**DIVISION OF RATEPAYER ADVOCATES  
CALIFORNIA PUBLIC UTILITIES COMMISSION**

**Report on the  
Pipeline Safety Enhancement Plan of  
Pacific Gas and Electric Company**

**R.11-02-019**

January 31, 2012

1 Figure 13 – Results of PG&E QRA analysis for entire PSEP

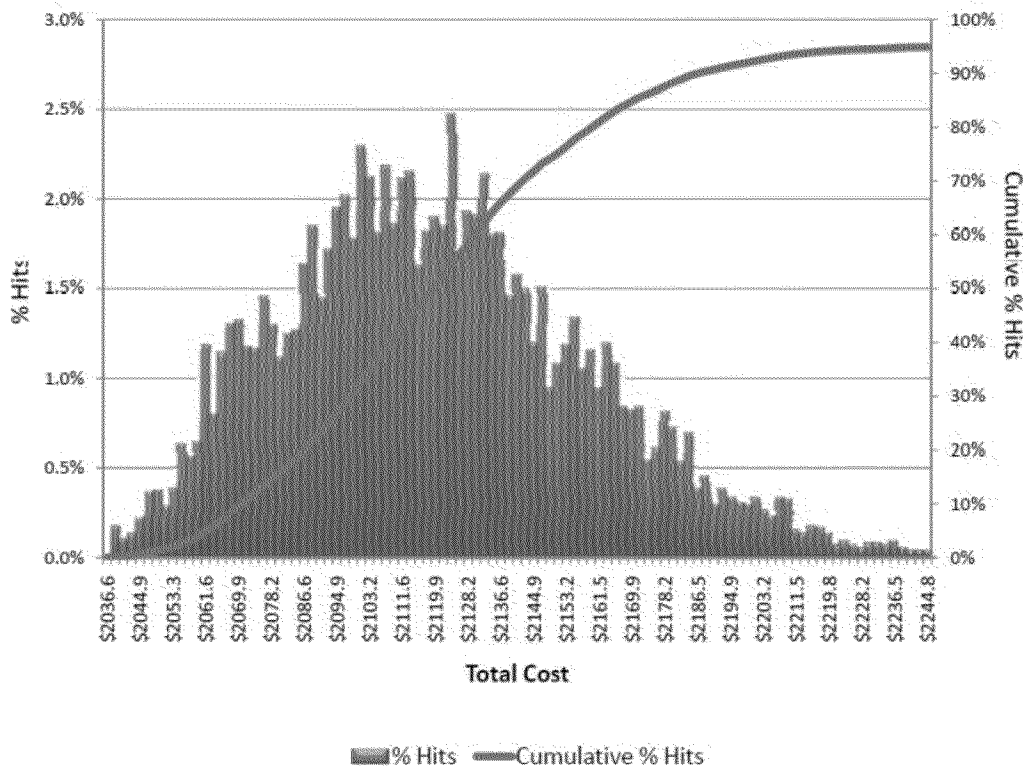
<sup>188</sup> Figure 7-5 in PG&E’s Testimony is incorrect. See PG&E’s response to DRA data request DRA\_041-07. A corrected figure was provided in the January 20, 2012 Errata filing, p. 7-42.

1 Figure 7-5 would show that there would be a probability of greater than zero (P0)  
2 that actual costs will be less than the 2,036.6 million PG&E shows in Figure 7-5.  
3 If PG&E were to use the ACEI Classification Range (-30% to +50%) shown in  
4 Table 7-6 for Class 4 estimate, it can be argued that the P0 values should be even  
5 *less* than the baseline cost of \$1,803.4 million. Given that DRA's analysis shows  
6 PG&E's baseline cost estimate to be higher than industry averages, the QRA  
7 should show a significant probability that actual costs could be lower than the  
8 baseline estimate. The histogram shown in Figure 7.5 does not show distribution  
9 of outcomes for actual costs on either side of the base estimate as the ACEI  
10 range for a Class 4 estimate would indicate. At a minimum, the QRA should show  
11 a significant probability that actual costs could be less than PG&E's current

1 Figure 15 – PSEP Contingency request for pipeline replacement compared to  
 2 PG&E QRA results<sup>191</sup>

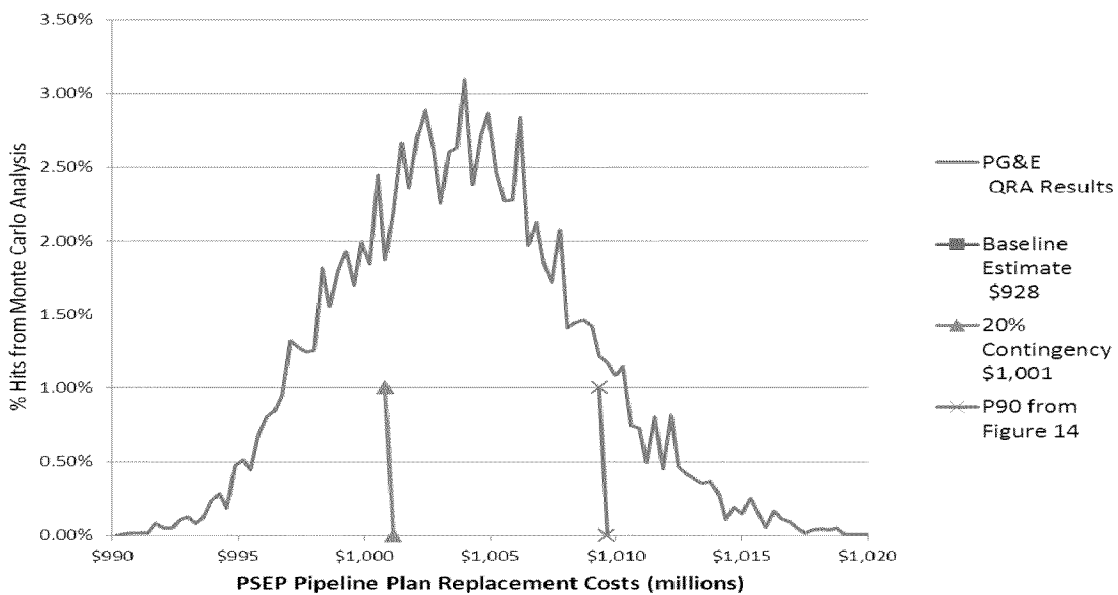
5 Figure 15 illustrates that PG&E’s QRA provides outcomes roughly  
 6 centered on the 20% value chosen by PG&E, but skewed to the right (greater  
 7 probability of higher cost). This figure also illustrates the discrepancy mentioned  
 8 in footnote XXX of this exhibit, since PG&E’s 20% contingency is supposed to be  
 9 a P90 value. It is clear from this figure that the 20% contingency is not a P90  
 10 value.
